Development Review Committee
Government Center Complex Conference Room, Building C
July 6, 2005- 4:00 p.m.

AGENDA
DEVELOPMENT REVIEW COMMITTEE

Case No. C-007-03
New Town: Town Center Parking Overview—Annual Review
Staff Report for the July 6, 2005 Development Review Committee Meeting

*James City County Environmental Division
Kingsmill – Spenser's Grant
County Plan Number S-053-05
June 22, 2005*

JCSA JAMES CITY SERVICE AUTHORITY	RESIDENTIAL GRINDER PUMP INSTALLATION	DWG NO. GP-1	SCALE: NONE
		DWN BY:	DATE: 1-1-2002

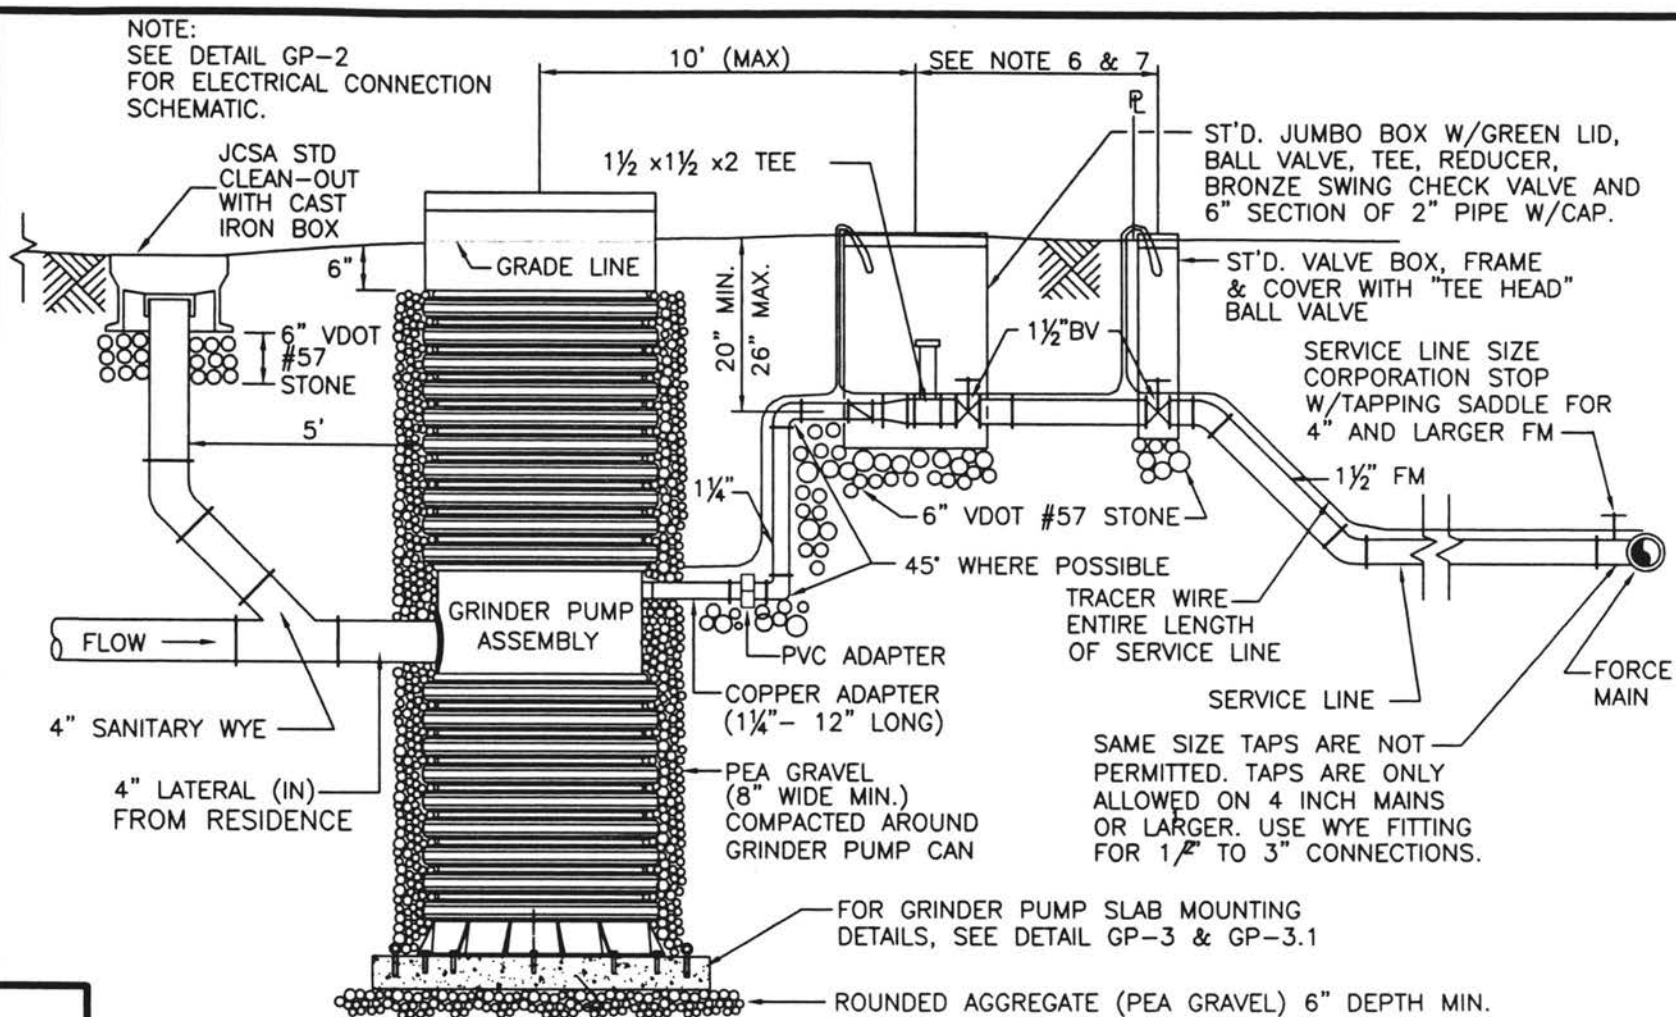
1. JCSA Detail References: Delete the GP-1, GP-2 and GP-3 details. These details have been superceded. Provide the attached revised GP-1, GP-2 and GP-3 details on the plans.
2. Is the "Pipe Trench and Bedding Detail" shown intended for storm sewer piping only? Revise title or provide note for clarification.
3. Grinder Pump Notes: Provide clarification of which lots are proposed for grinder pumps. Based on the plans, it appears all lots will be not served by grinder pumps. Revise plan accordingly.
4. Grinder Pump System: Revise Note # 10, deleting all Model 210 grinder pump designations.
